Appl. No.: 10/526,593  
Reply to Office Action of: 08/03/2006

**Amendments to the Drawings:**

FIG. 3

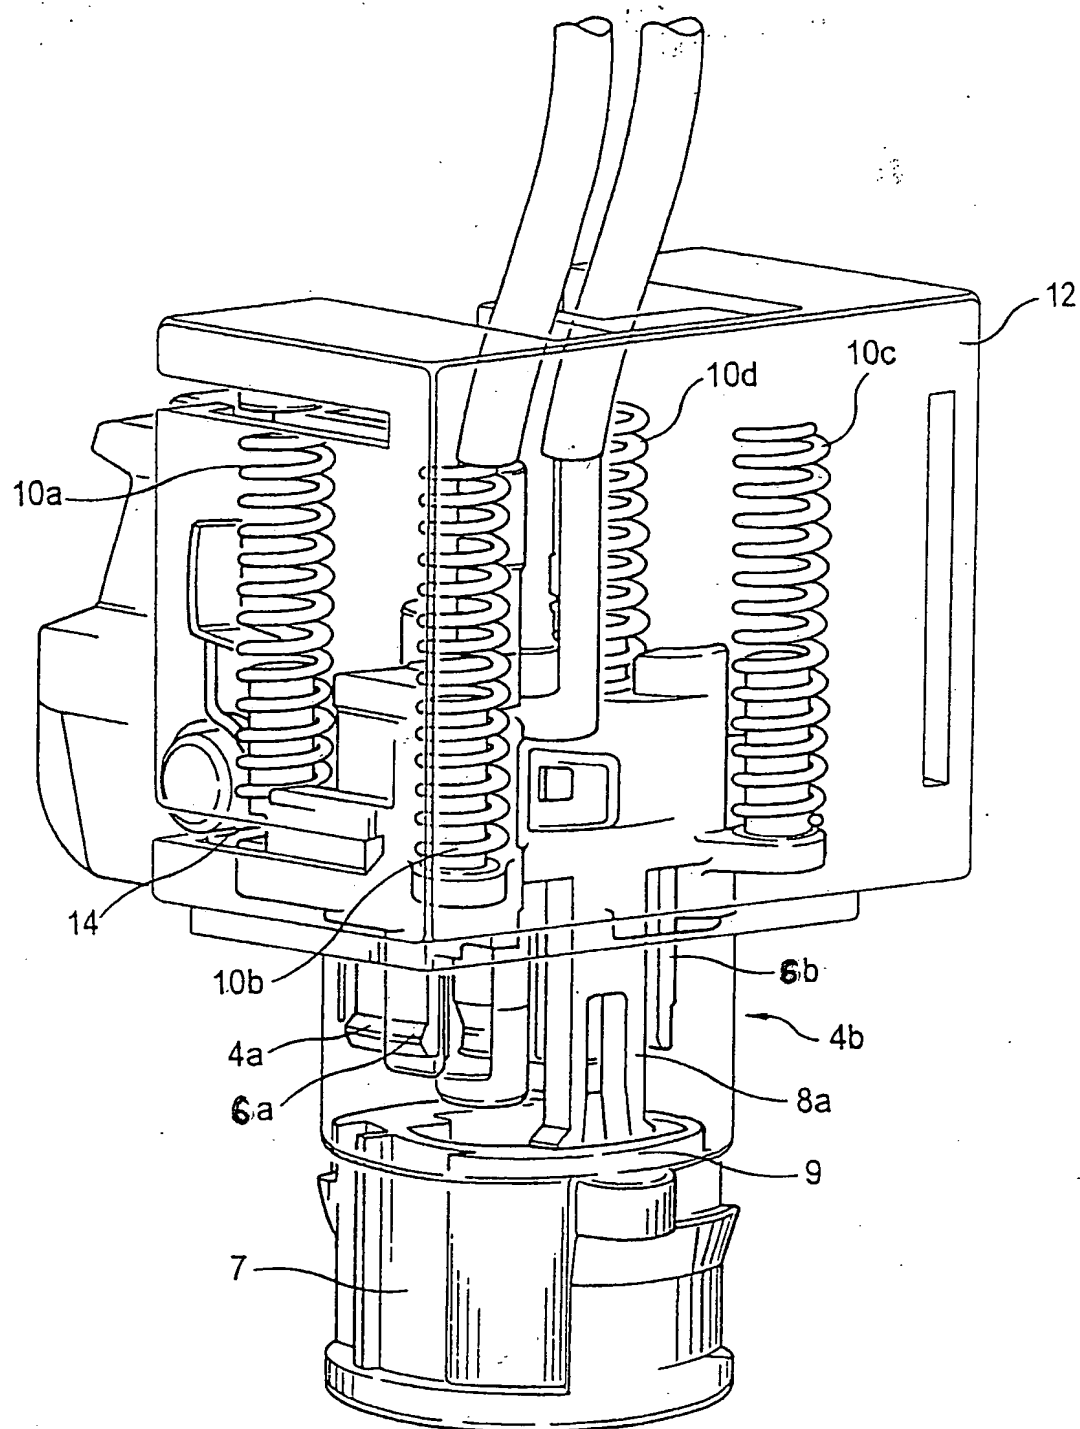
The attached sheet of drawings includes changes to Fig. 3

"8b" has been corrected to --6b--.

"8a" (first occurrence) has been corrected to --6a--.
